Mapleton City

Planning Commission Staff Report

Item 3

Consideration of Preliminary Plat, Project Plan and Conditional Use Permit applications for the Harvest Park Condominiums Plat "A" subdivision consisting of two mixed use buildings with commercial on the ground floor and residential above located in the General Commercial (GC-1) zone.

1 A001 ARCHITECTURAL SITE PLAN
SCALE: 1"=20'

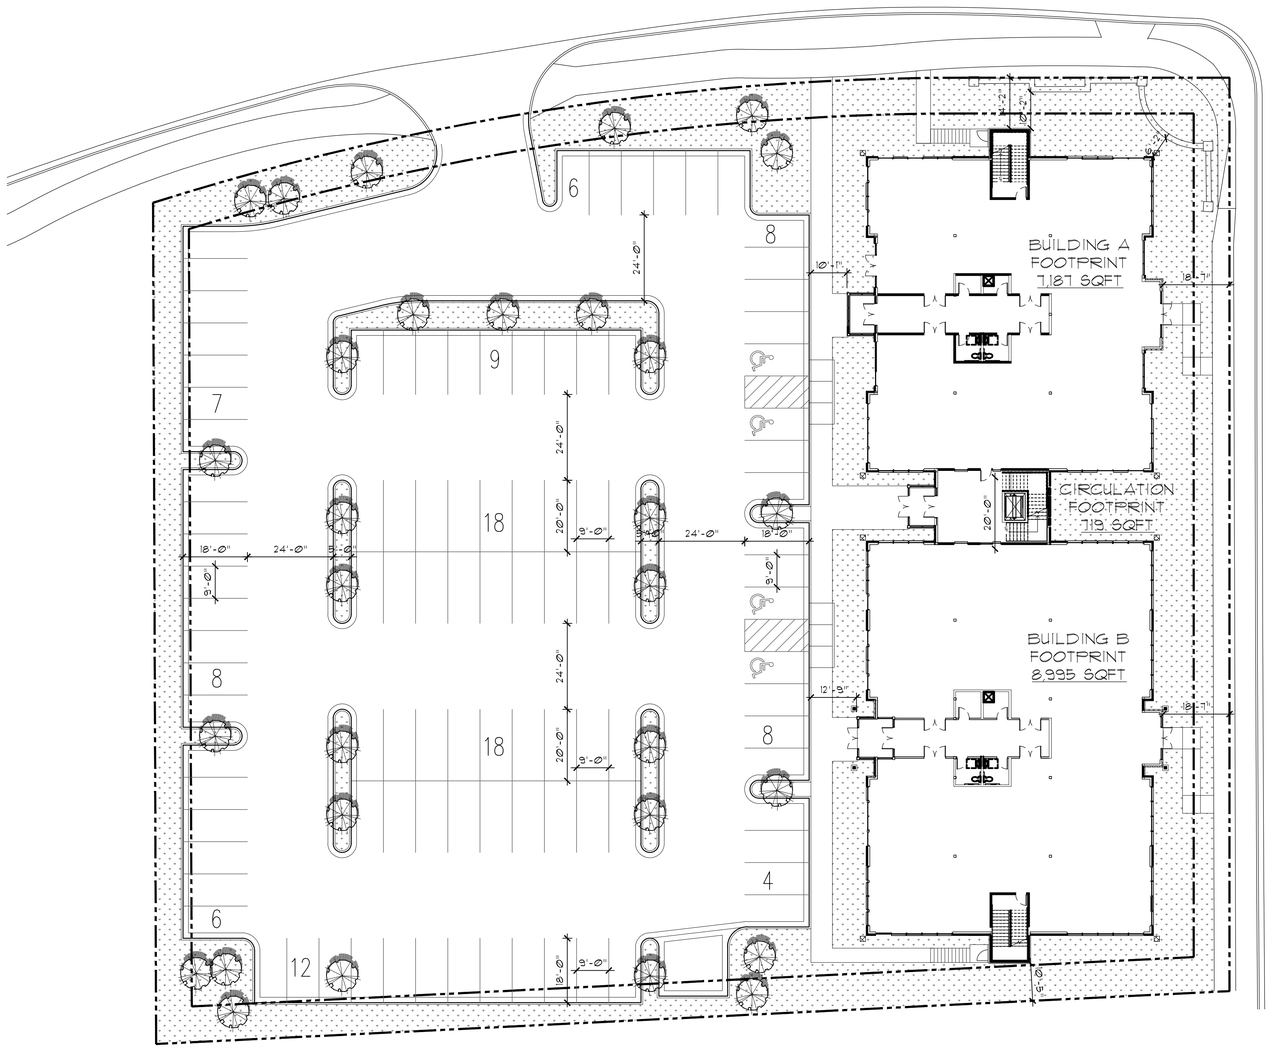
6) Please update the parking study.

Response: MCC chapter 18.92.030.K establishes the off-street parking requirements for commercial projects. This code identifies a range of uses, and parking requirements based on those uses. The requirements range from one space for every 150 square feet of floor area to 1 space for every 600 square feet of floor area, depending on the use.

The applicant has not yet identified what type of uses may occupy the commercial spaces, therefore to be conservative staff has assumed the requirement to be one space for every 200 square feet of commercial area, for a total requirement of 81 commercial paces. The residential parking requirement is 36 spaces. If you combine the total commercial and residential uses, the total requirement would be 117 spaces.

The current site plan shows 104 park spaces. If it is assumed that the commercial units will be occupied by uses that require at least one space per 200 square feet, then the Commission would have to authorize the sharing of 13 spaces, or 11% of the total required parking. A parking study by Hales Engineering has been updated to evaluate the shared parking request (see attachment "2"). The evaluation indicates that it is generally good practice to have approximately 10% additional spaces above the estimated max demand as a buffer to avoid vehicles being unable to find a space. The evaluation concludes that during most of the average day, there would likely be more than 10% additional parking to meet demand. However, during the peak time of parking demand, it is estimated that only 5% of the parking spaces might be available, if the commercial spaces are occupied by uses that require one space for every 200 square feet of floor area.

1. The applicant is allowed to share 13 parking spaces between the residential and commercial uses. The uses that occupy the commercial building spaces shall be limited to those uses that would not exceed 81 total parking spaces based on City code.
2. Solid fencing shall be installed along the west and south property lines.
3. A separate sign application shall be submitted for all signage proposals.

HARVEST PARK CONDOMINIUMS

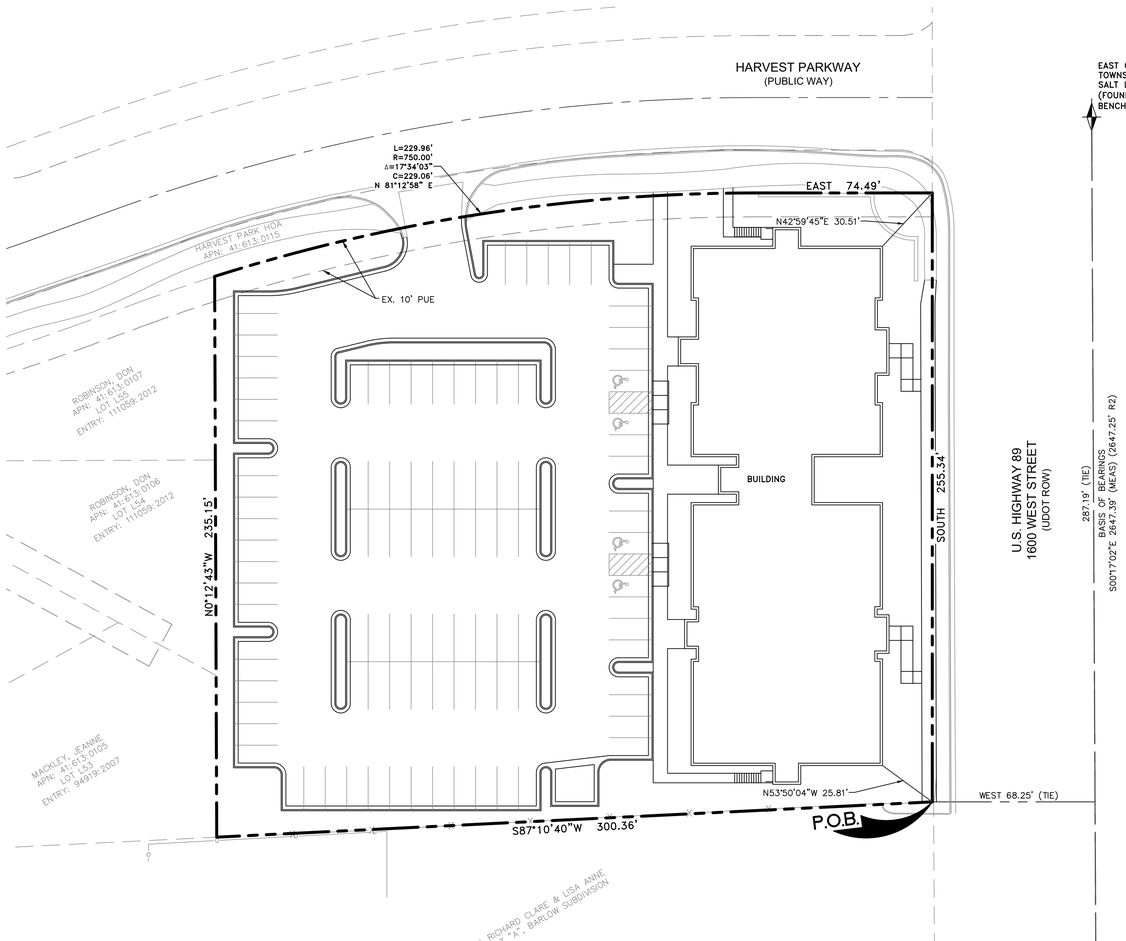
1. The plat doesn't label the parking area or area around the buildings as common area.
2. Please include the address of 826 S 1600 W next to "Harvest Park Condominiums" at the top of the first page of the plat.
3. Each unit will need its own meter. No master meters will be approved.
4. Max parking lot light pole height is 16'. Plan shows 16' but table on sheet esp100 shows it as 20'.
5. Provide verification that access issues have been resolved with Harvest Park HOA.
6. Provide a written response to the Planning Commission's questions regarding:
   -Snow removal
   -Construction access

Harvest Park Commercial South Parcel Construction Plan

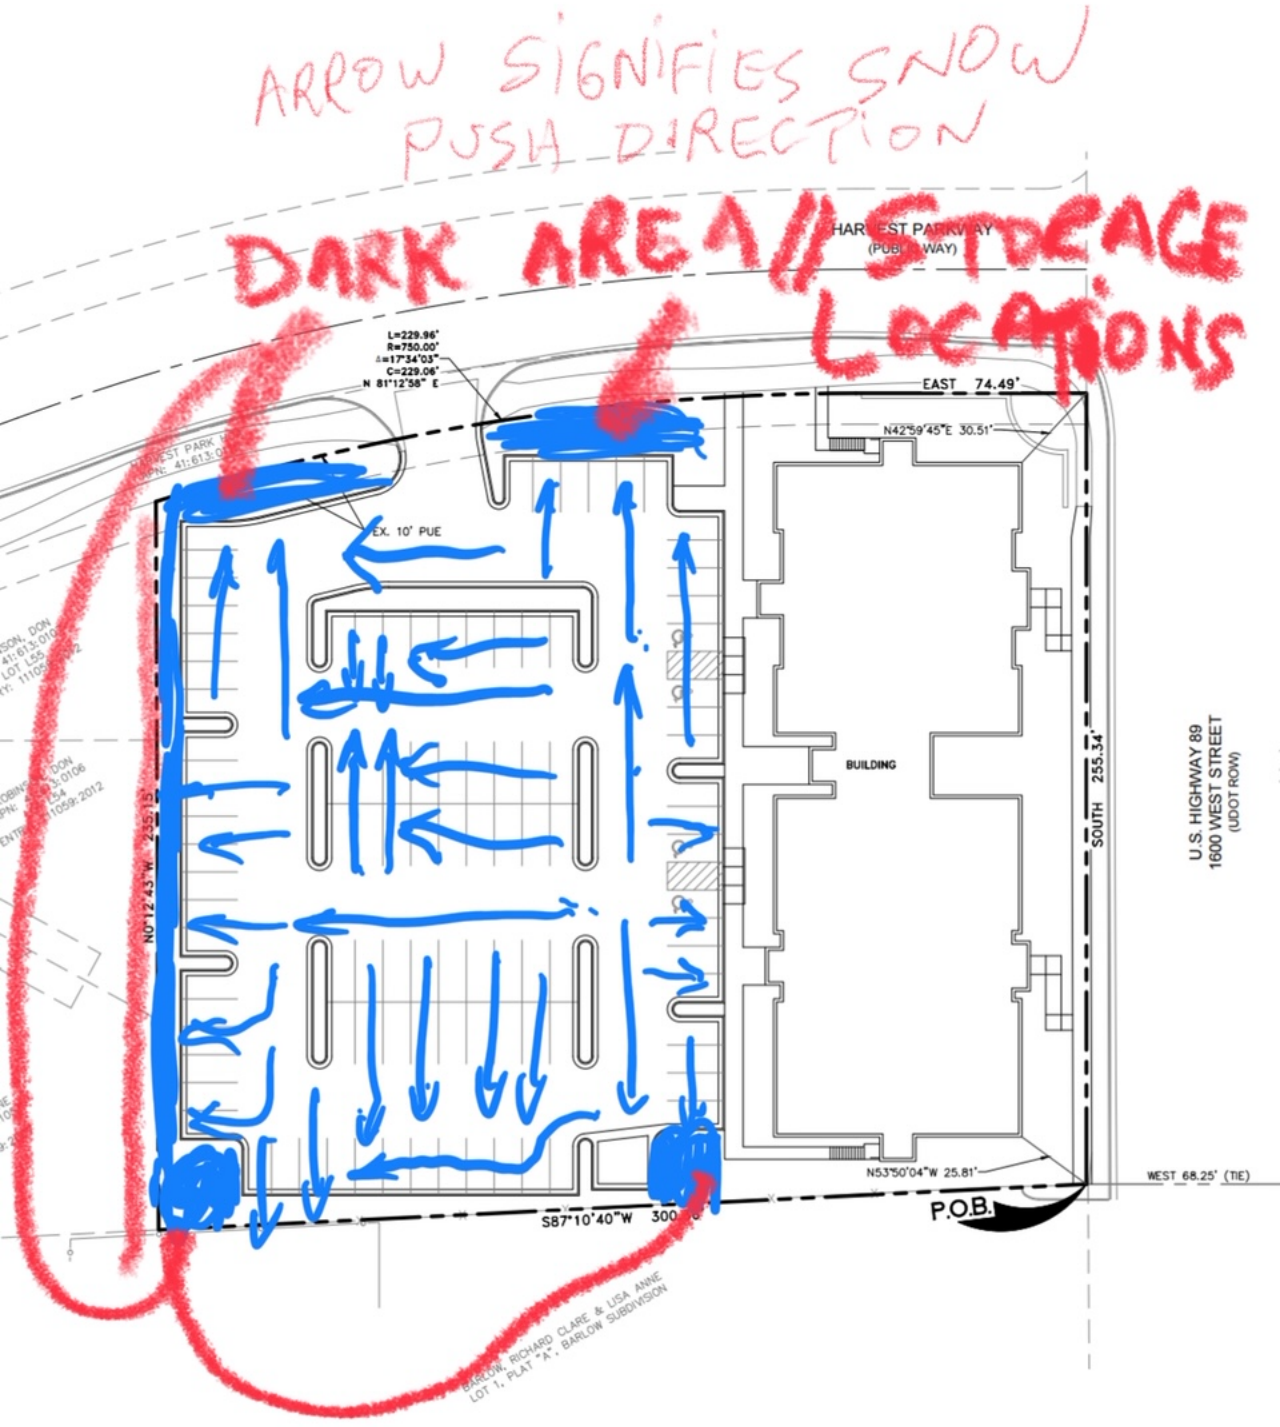
4) Please address how construction traffic will be handled and whether access from Hwy 89 would be possible.

#3 “How construction traffic would be handled.”

Response: The applicant has submitted a conceptual traffic plan that would include the possibility of construction vehicles accessing the site off of Highway 89. A final traffic control plan will be required prior to construction.

Harvest Park Commercial believes the construction traffic impact shall be minimal due to the location of the property as well as the proximity to a main arterial road. The ability to import/export materials needed for construction shall occur during business hours using the main arterial roads adjacent to the project. All construction materials shall be stored on-site and shall be stored in a safe and orderly fashion to allow for quick and easy access on and off the site for construction deliveries. Any contractor working for or on behalf of the Harvest Park Commercial project shall don all necessary PPE and shall be trained accordingly.

Figure 1 US-89 / Harvest Parkway Entering Vehicle Volume Comparison

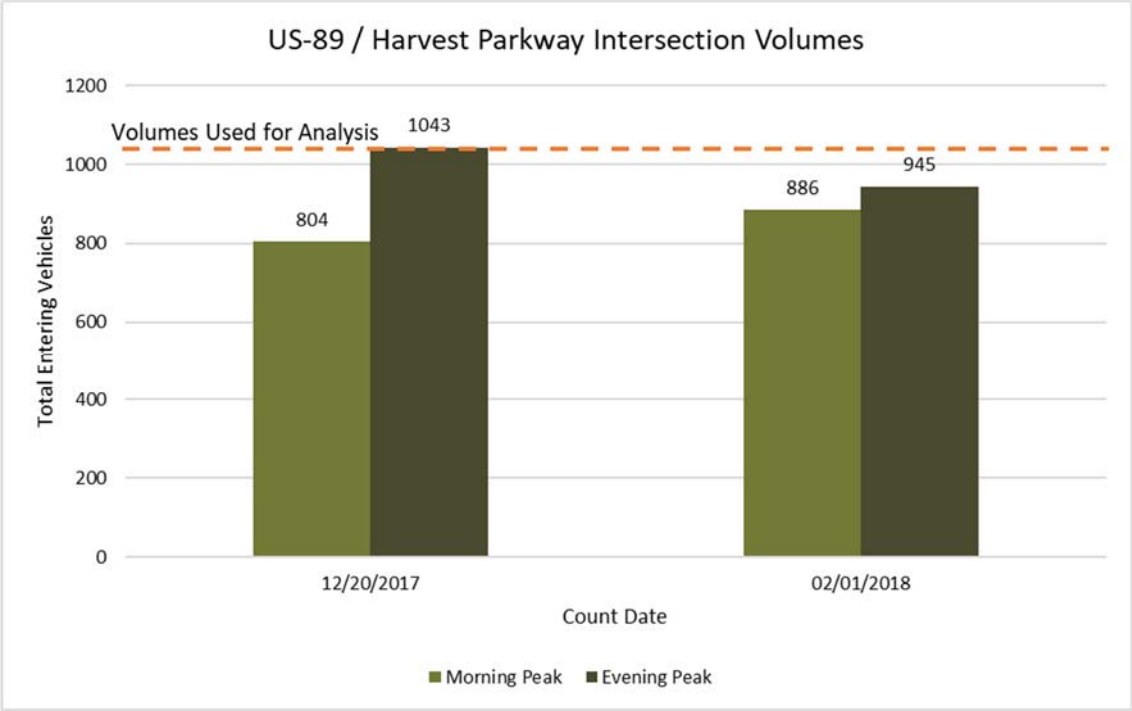
2) Please revise the traffic study to include more traffic counts.

The turning movement counts were compared with the counts performed in December 2017. As shown in Figure 1, the evening peak hour entering vehicles (volume) in December was approximately 98 more than the entering vehicles in February, however, the reverse is true for the morning peak hours, e.g., the entering vehicles (volume) in December was lower than the volume in February by 82 vehicles. However, since the evening peak hour counts in December were greater than all other peak hour volumes from December or February, the peak hour analyses were completed for a "worst case" scenario, therefore, there is no need to re-evaluate the February data.

Response: The traffic study reviewed by the Planning Commission in 2018 determined that the project would not create significant impacts on the adjacent streets. However, there was some concern expressed by the Commission, and the public, that the traffic counts were only done on one day. The Commission asked that additional traffic counts be taken.

The traffic engineer collected traffic collected additional as requested by the Commission. The traffic counts were lower than the original counts and the engineer determined that the conclusions of the original report were justified (see attachment "2").
